Product Change Notification

1. ECR #: 167953
Notification #: 404

2. Date of Announcement: May 30, 2018

- IPBD - Power Cable Connector
- PMSD - .165 SOCKET DISCREET CABLE ASSEMBLY
- PMSDT - .165 SOCKET DISCREET CABLE ASSEMBLY

4. Part #'s Affected

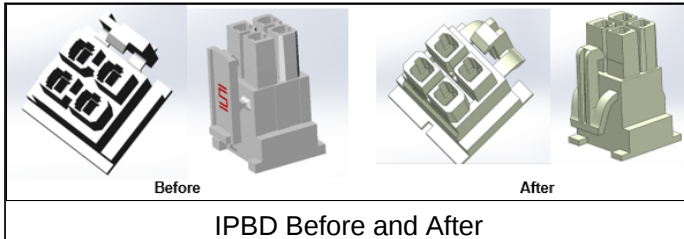
Samtec is revising the geometry and material for IPBD-D to improve latch functionality

These revisions improve the ductility & durability of the latch. The force/distance to latch & unlatch the mated pair will not change. The force required to overcome the latch will remain the same. The void coring between contact posts was increased to optimize manufacturability using the new material. Existing mates will connect/perform without compromise. Existing contacts will fit without concession. No influence on crimp and poke assembly. These changes are backwards compatible.

- Form - Latch geometry change
- Form - Increased void coring between towers
- Fit - These changes are compatible with existing mates, and crimp-contacts
- Function - These changes will not influence mechanical or electrical integrity of the connection
